DRAWING TITLE INTERNAL CIVIL WORKS CONCEPT STORMWATER & DRAINAGE PLAN SHEET 1	JOB NUMBER SY230307	
	DRAWING NUMBER DA20.01	REVISION C
	DRAWING SHEET SIZE = A1	
	(Empty space for notes or additional information)

NOTE: DA20.01 & DA20.02 ARE INTENDED TO SUPERSEDE APPROVED CONCEPT PLANS DA5.01 & DA5.02.

UNITING SHELLHARBOUR
171 WATTLE ROAD
SHELLHARBOUR
CONCEPT MASTERPLAN

INTERNAL CIVIL WORKS
CONCEPT STORMWATER &
DRAINAGE PLAN
SHEET 2

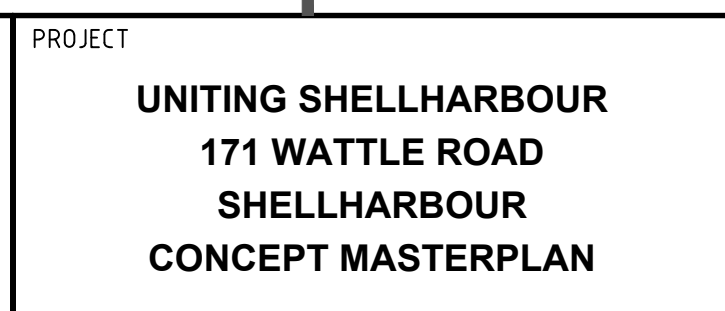
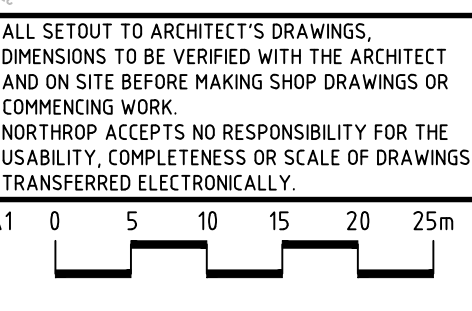
1.	STORMWATER DISCHARGE LOCATION CHANGED FROM NORTHERN BOUNDARY TO CONNECT INTO PROPOSED REALIGNMENT OF COUNCIL DRAINAGE EASEMENT DRAINING INTO THE WESTERN DETENTION BASIN.
2.	PROPOSED ROADABOUT INTERSECTION REPLACED WITH DRIVEWAY LAYBACK AND VEHICLE CROSSING FOR SOUTHERN PROPERTY ACCESS.
3.	MINOR AMENDMENTS TO SUIT THE DETAILED DA SUBMISSION INCLUDING MINOR CHANGES TO EARTHWORKS LEVELS & CIRCULATION ROAD ALIGNMENT AND LAYOUT. REFER TO STAGE 1 DA CIVIL PLANS FOR ADDITIONAL INFORMATION.
4.	ADJUST PROPOSED ROAD LEVELS ALONG WESTERN BOUNDARY TO BE APPROXIMATELY 2.0m LOWER IN HEIGHT TO REDUCE RETAINING HEIGHTS AND IMPROVE PEDESTRIAN LINKS.
5.	REVISE OVERLAND FLOW STRATEGY TO REPLACE CULVERT CROSSING AT ROAD NUMBER 1 AND INSTEAD ALLOW SURFACE FLOW TO PASS ACROSS THE ROAD SURFACE WHILST MAINTAINING SAFE FLOW CONVEYANCE.

DA20.02

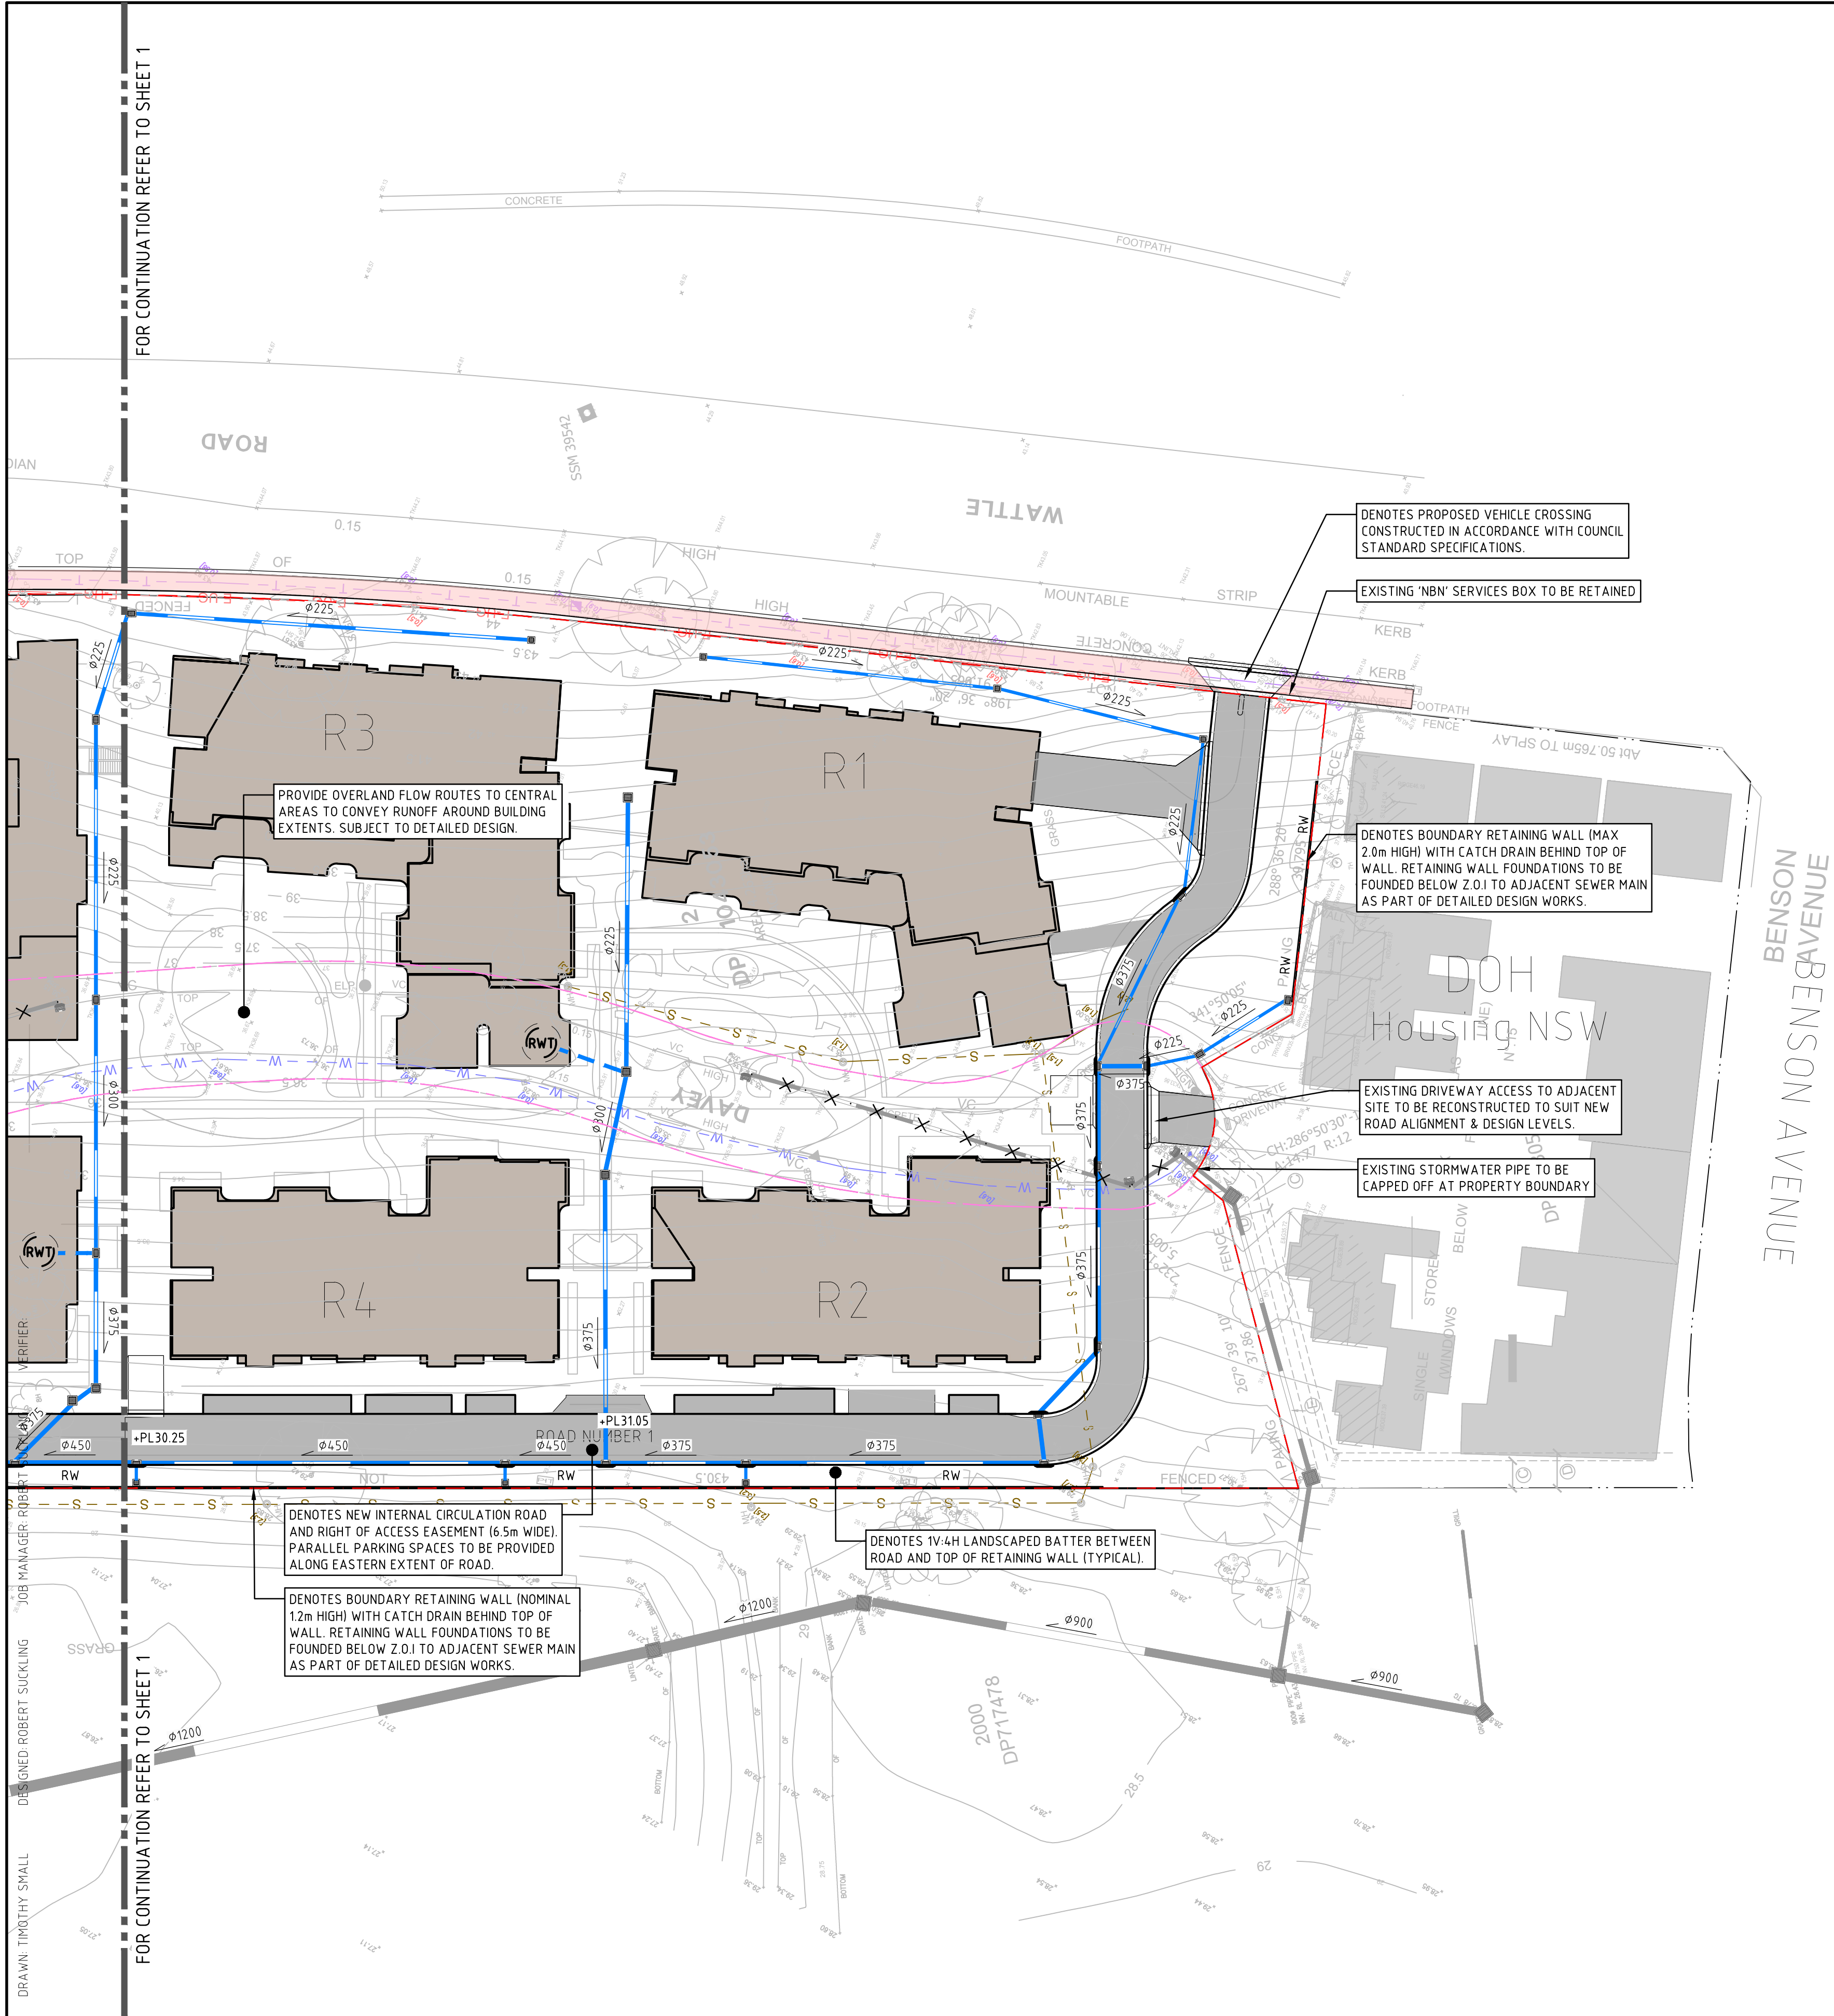
SCHEDULE OF KEY CHANGES AS PART OF MODIFICATION APPLICATION	
1.	STORMWATER DISCHARGE LOCATION CHANGED FROM NORTHERN BOUNDARY TO CONNECT INTO PROPOSED REALIGNMENT OF COUNCIL DRAINAGE EASEMENT DRAINING INTO THE WESTERN DETENTION BASIN.
2.	PROPOSED ROUNDABOUT INTERSECTION REPLACED WITH DRIVEWAY LAYBACK AND VEHICLE CROSSING FOR SOUTHERN PROPERTY ACCESS.
3.	MINOR AMENDMENTS TO SUIT THE DETAILED DA SUBMISSION INCLUDING MINOR CHANGES TO EARTHWORKS LEVELS & CIRCULATION ROAD ALIGNMENT AND LAYOUT. REFER TO STAGE 1 DA CIVIL PLANS FOR ADDITIONAL INFORMATION.
4.	ADJUST PROPOSED ROAD LEVELS ALONG WESTERN BOUNDARY TO BE APPROXIMATELY 2.0m LOWER IN HEIGHT TO REDUCE RETAINING HEIGHTS AND IMPROVE PEDESTRIAN LINKS.
5.	REVISE OVERLAND FLOW STRATEGY TO REPLACE CULVERT CROSSING AT ROAD NUMBER 1 AND INSTEAD ALLOW SURFACE FLOW TO PASS ACROSS THE ROAD SURFACE WHILST MAINTAINING SAFE FLOW CONVEYANCE.
